BURLINGTON DEVELOPMENT REVIEW BOARD

MEMORANDUM

RE: ZP15-0738CA; 747 Pine Street

Request: Renovation to existing warehouse building; removal of approx. 8,700 building addition, exterior façade upgrade, improved stormwater management, add parking.

PERSPECTIVE LOOKING NORTH

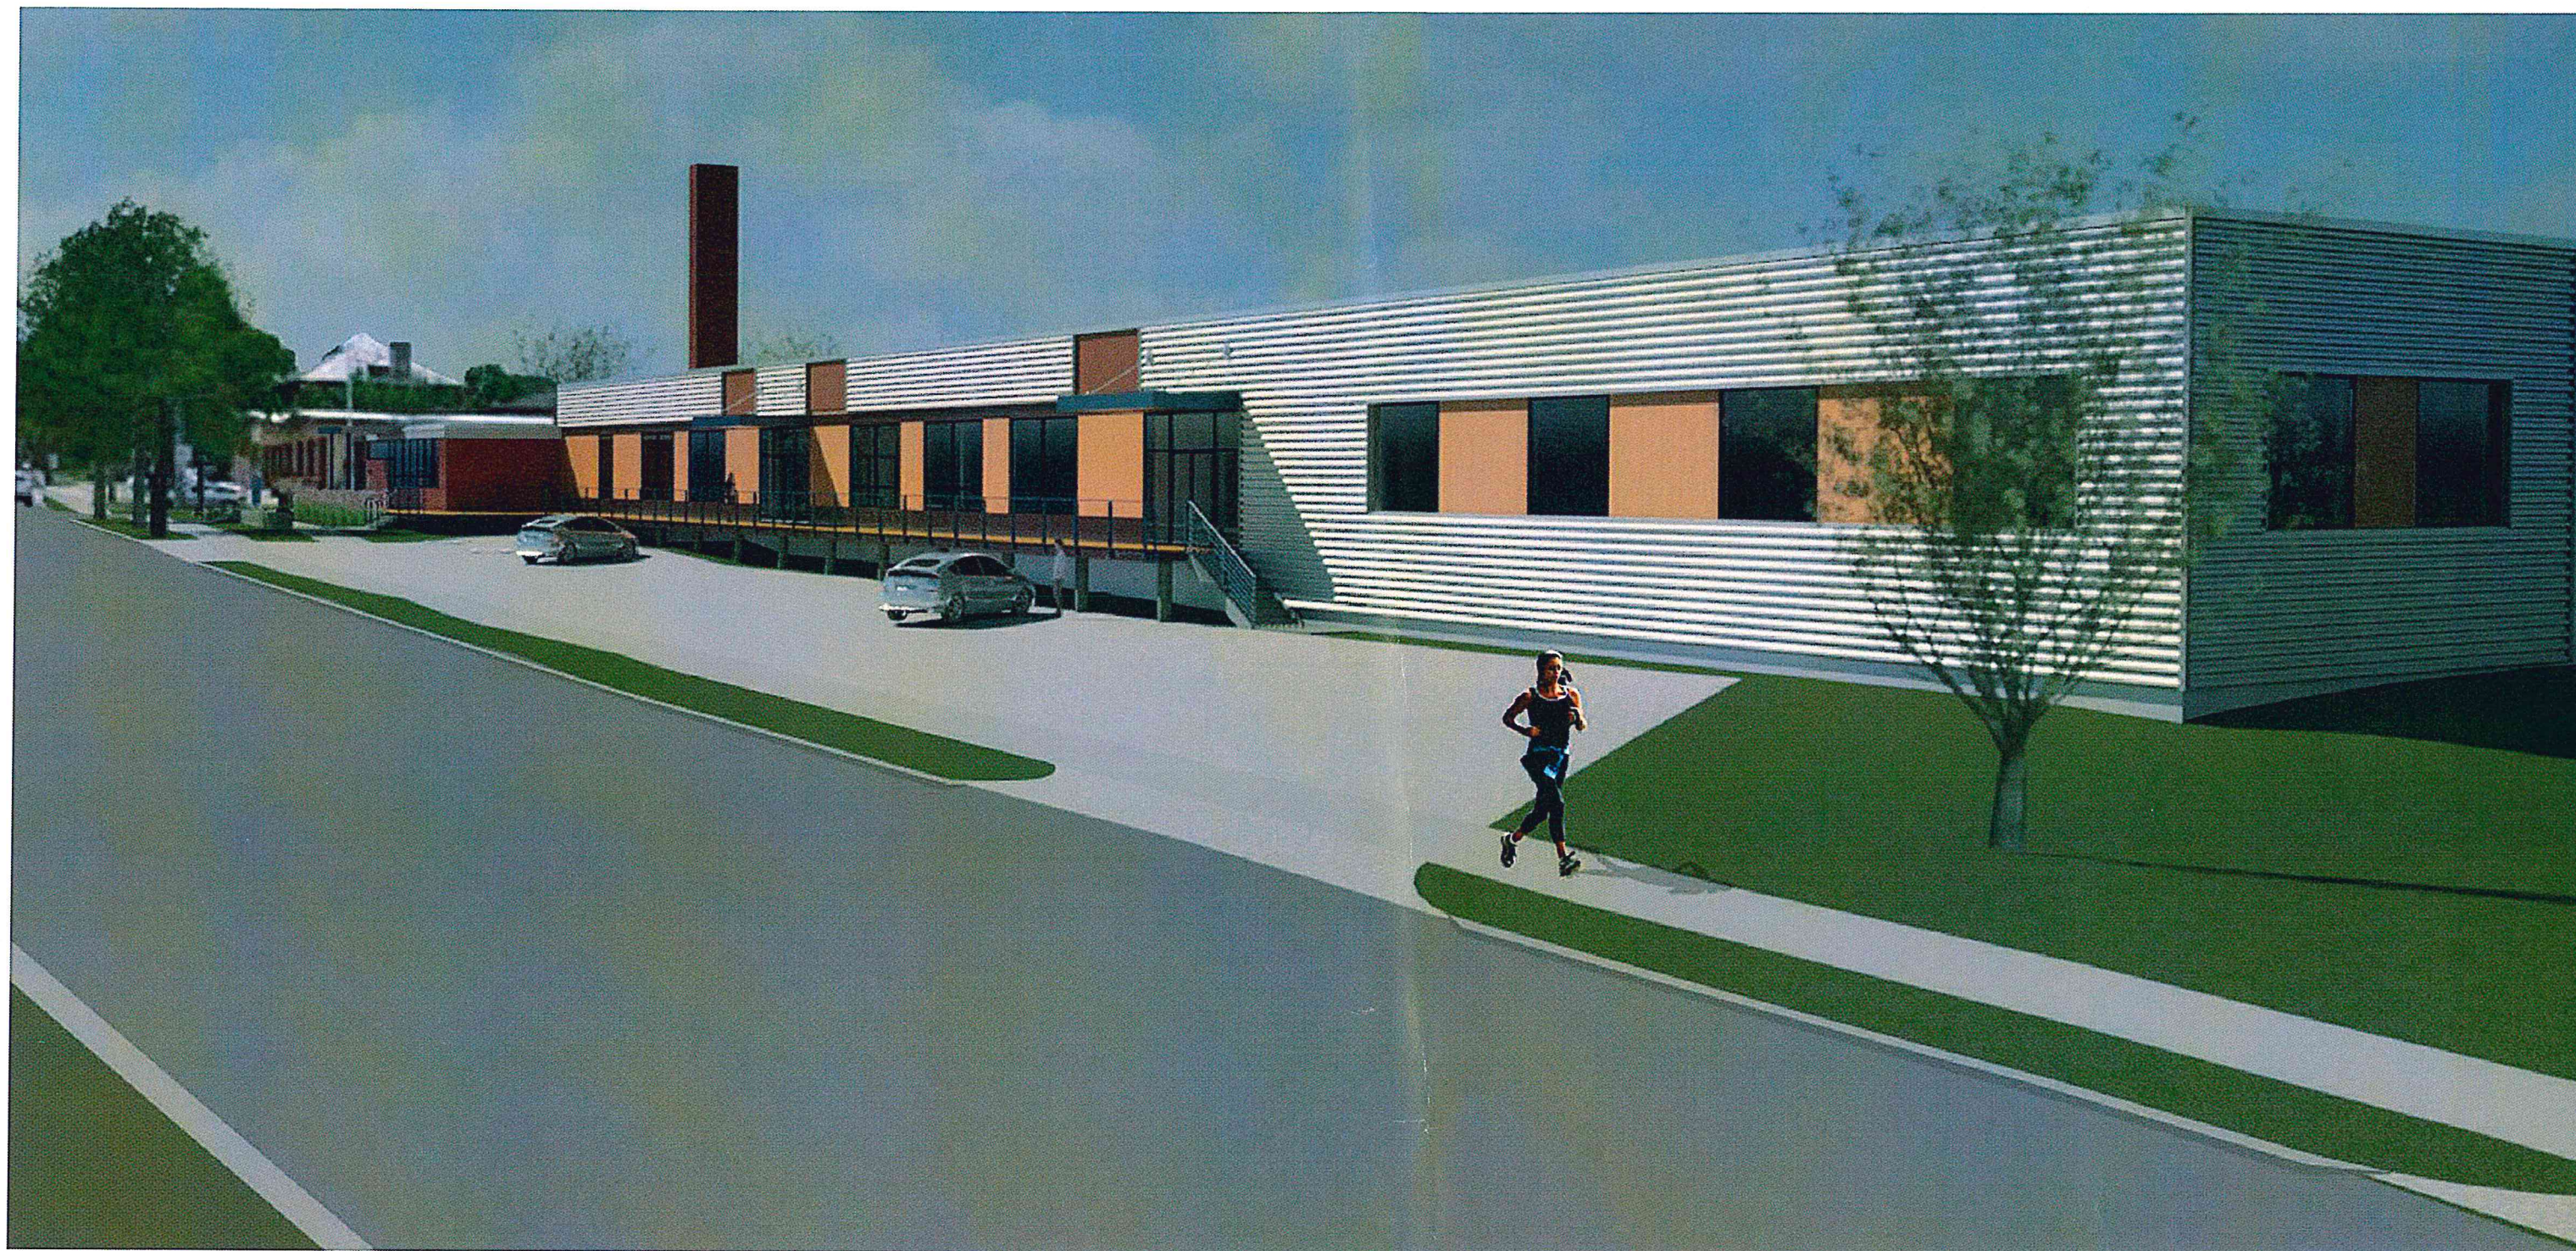
If any additional HVAC or other mechanical equipment is proposed (including roof-top, as alluded to in P5 Perspective plan), information and anticipated sound levels will need to be provided. Staff can review for any screening need. **Affirmative finding as conditioned.**

① PROPOSED ELEVATION - EAST
3/32" = 1'-0"

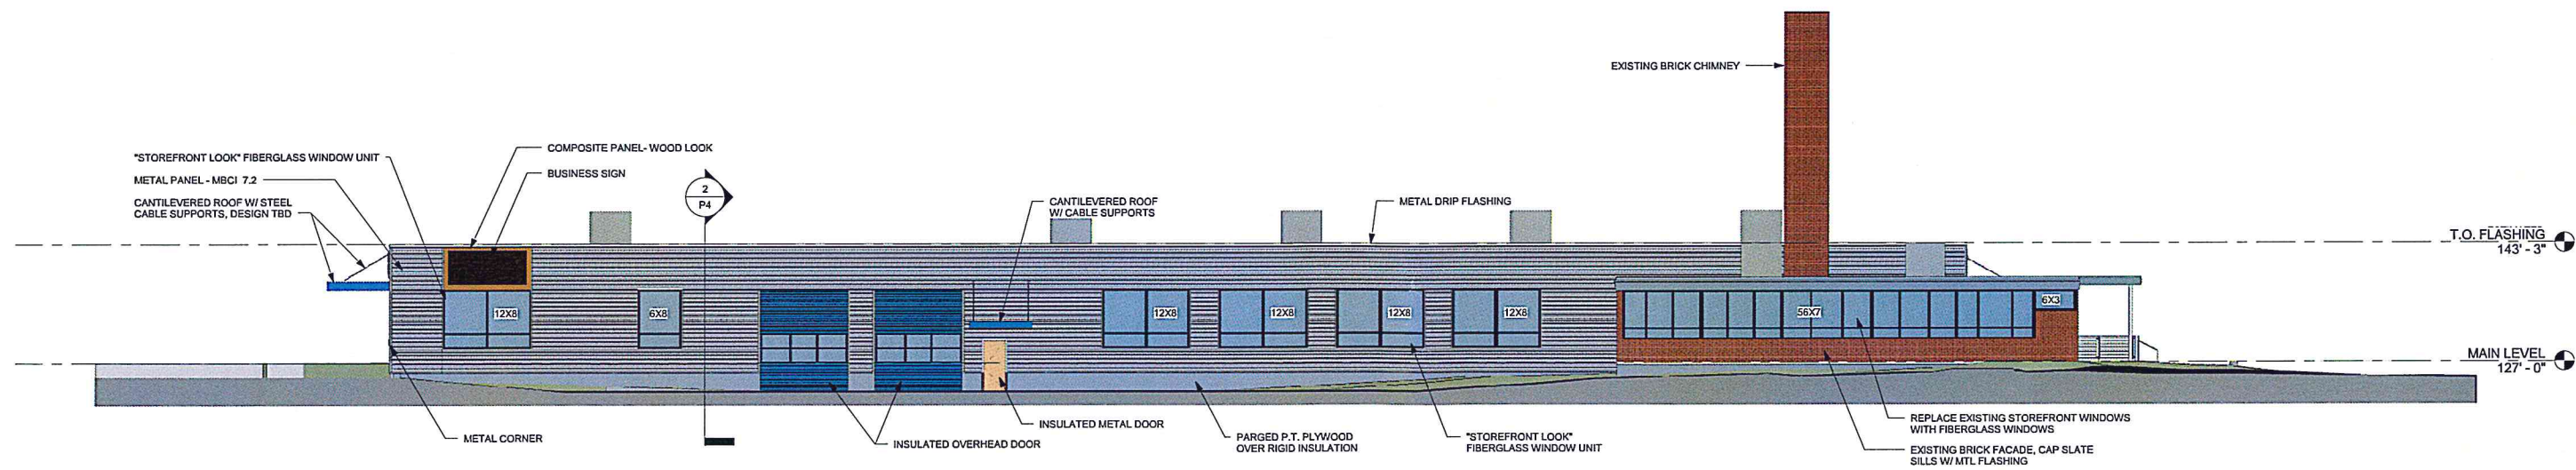
The principle entrance from Pine Street will be clearly identifiable via the enhanced entrance porch proposed. Dual aluminum storefronts in the rear (west) of the building will clearly define separate business entrances from the parking area(s). Multiple single doors will be available on the west and south elevations.

Replacement fiberglass “storefront” windows circle the building, repeating consistent patterns and are appropriate to the anticipated use. Given the context, vertically proportioned window arrangement is not consistent with the building type, so would not apply in this situation.

JOB NAME: 747 PINE STREET - SITE
DATE: 12/16/2014
APEX LIGHTING SOLUTIONS
REFLECTANCES: NONE USED
WORKPLANE: 8' GRADE

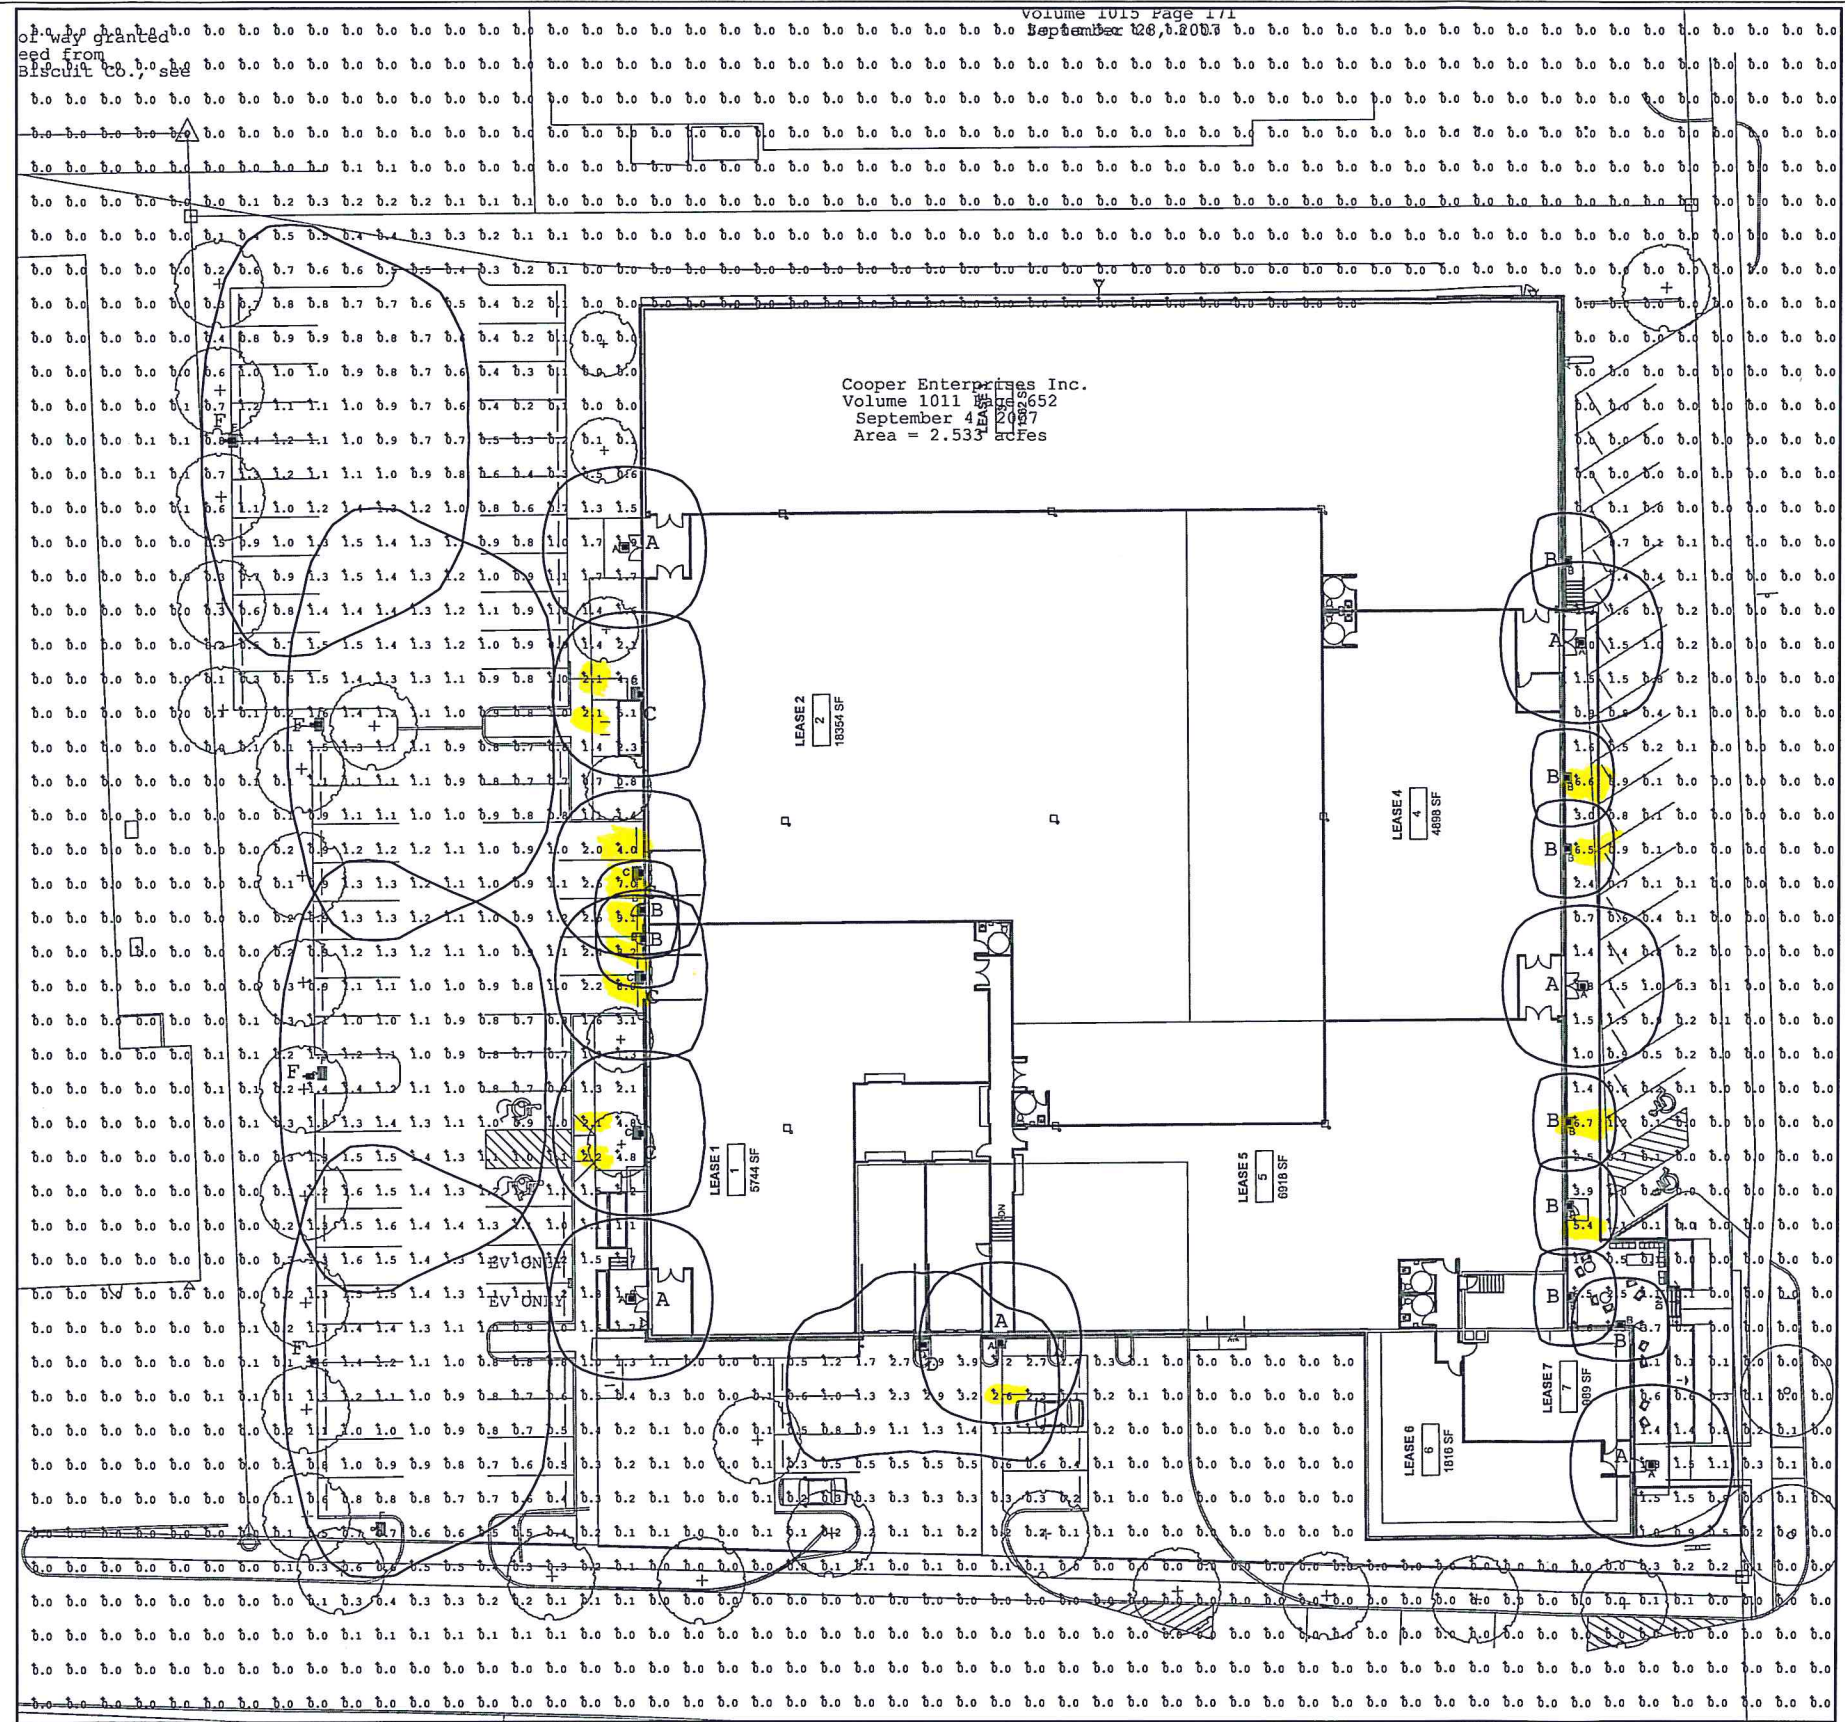
Lighting fixtures and illumination must comply with this standard. A photometric has been submitted with the application, and reflects some “hot spots” and footcandle measurements that exceed allowable limits. The following issues will need to be addressed:

1. Walkway lighting may not exceed 2 fc at any point, with average not to exceed 0.5 fc.
(Section 5.5.2 (f) 2.)
2. The maximum mounting height for parking lot lighting is identified (25 ft), but the maximum fc. measurement within the parking lot area is limited to 4.0. The photometric defines the max as 9.0, (near westerly doors) which is excessive.
3. Lighting at building entrances may not exceed 5.0 fc; which is in conflict with the submission.

4. Section 5.5.2 (f) 2. C. informs that lighting fixtures shall have an initial output of not more than 1,200 lumens. Fixture “A” is proposed to have twice that amount. The fixture shall be revised to meet these standards.
5. Fixture “B” appears to be a point source for excessive fc. measurements, and needs to be adjusted.
6. One light fixture (EON Sign 303-s1) is identified as an adjustable LED sign lighting luminaire. Sign illumination is not permitted in the Enterprise zones.
A revised photometric which corrects these irregularities must be supplied to meet the requirements of these standards. **Affirmative finding as conditioned.**

The submission includes spec sheets for LED lighting, which is generally acceptable. The submitted photometric illustrates some “hot spots” that will need to be adjusted to be compliant with Section 5.5.2 of the ordinance (see comments above.) Revised plans can be reviewed for compliance by staff. **Affirmative finding as conditioned.**

1. A revised lighting plan with lumens information and meeting the standards of Section 5.5.2 shall be submitted to staff for review and approval **prior to release of the zoning permit.**
2. No use permits are issued with this approval. Any changes of use; in whole or in part shall require separate permitting.
3. Signs shall require separate permitting.
4. Written approval of the EPSC plan from the City Stormwater Engineer will be required **prior to release of the zoning permit.**
5. Parking requirements will be calculated when new uses are identified by the applicant. Any change(s) of use will require a zoning permit.
